# **Design to the Fire Alarm Code, NFPA 72-2007 (Live Webinar)**

### Commentary on New York City School Construction Administration Construction Specification 16720, Fire Alarm

ILLUSTRATION OF MULTIPLEXED OPERATION

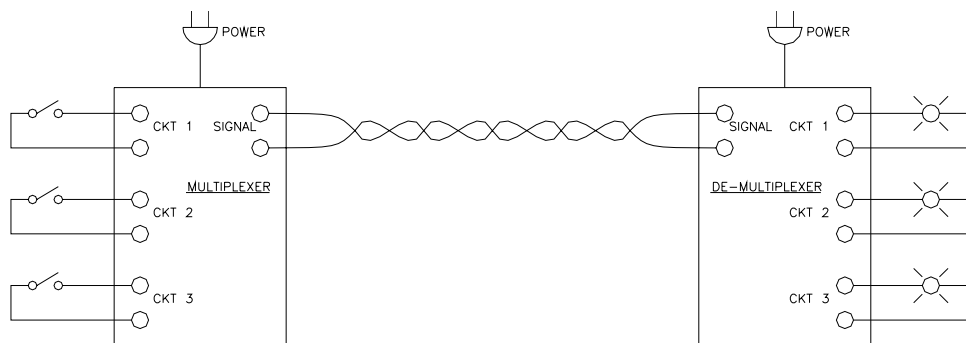
Why should CSA overlook the analog feature? This comes back to the decision to mix-and-match components. It is fairly easy to multiplex discrete (off-on) signals, as illustrated below:

The operation indicated is based upon a 12-cent parallel-to-serial / serial-to-parallel converter chip. 24 VDC-in and 24 VDC-out are standard values. If a "power load" is connected, then a driver is needed, but for a solid-state input, chips talk to chips fairly well.

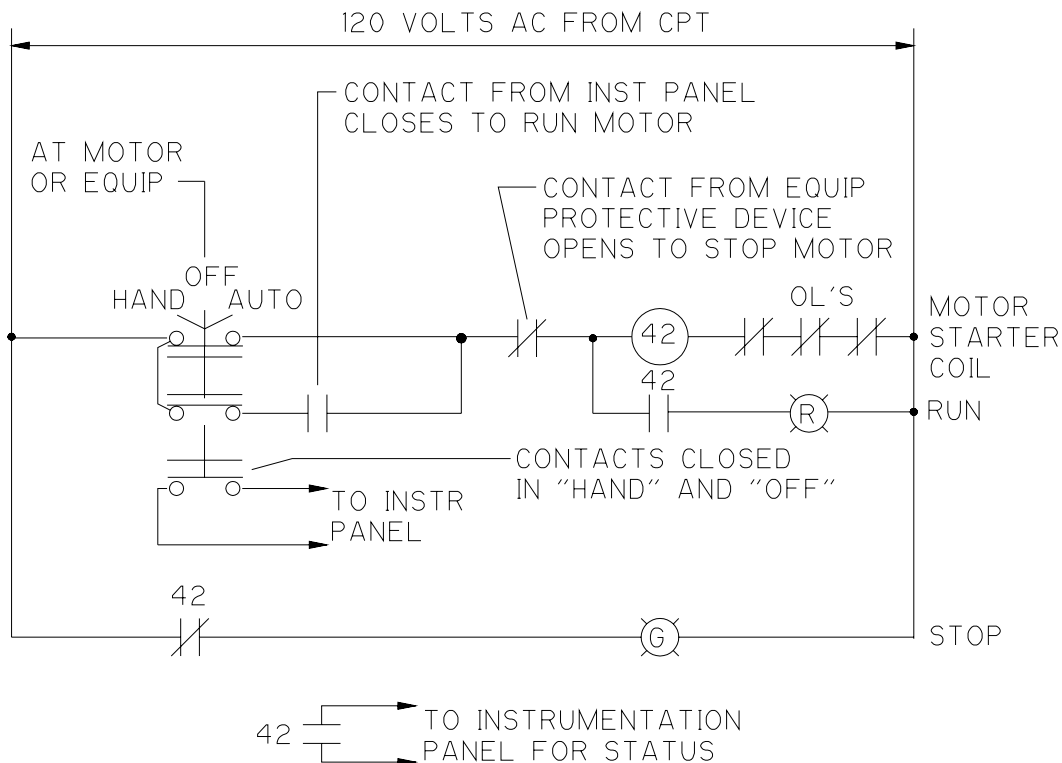
**1.03 Related Work** - this is a good list of equipment provided by others which require connection to the fire alarm system by the Electrical Contractor. Missing, however, is any mention of “supervised” connections. NFPA 72 is very explicit in identifying the correct way to connect the fire alarm to the elevator shunt-trip circuit breaker. [“Supervised” means that a wire short or break is alarmed as TROUBLE on the FACP.] This section leaves the contractor wondering whether supervisory relays are required or not.

"...kitchen fire extinguishing system...shall be annunciated at the fire alarm control panel." Is it annunciated as TROUBLE or as EVACUATION? Especially in a school, a good suppression system avoids the need to evacuate after a minor problem in the kitchen or home ec room..

Models SIGA-CT1, SIGA-CT2 & SIGA-MCT2

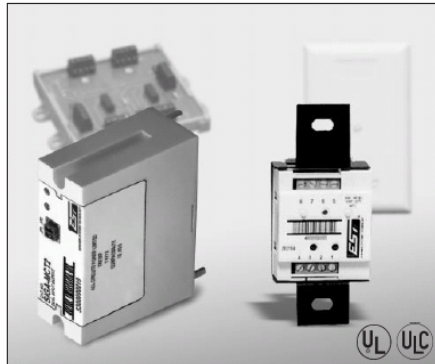
A Fire Alarm Request For Proposal dated March, 2006, from NYC SCA, is available at [http://www.opt-osfns.org/Destination/CMS/Upload/bids/Fire\\_Alarm\\_System\\_Spec.pdf](http://www.opt-osfns.org/Destination/CMS/Upload/bids/Fire_Alarm_System_Spec.pdf). It calls for single-source module EST model SIGA-CT1. Below is a Mexican picture of the SIGA-CT1 from <http://www.dico-mexico.com/catalogo/edwards/pdf/Modulo%20de%20Control.pdf>:

Note that this device is in the INTELLIGENT ANALOG DEVICES section of the catalog and is being used with off-on switches. This is not a coordination problem. The application portion of the catalog demonstrates this use and gives wiring details. Again, however, the sole-source interface forces selection of the FACP.
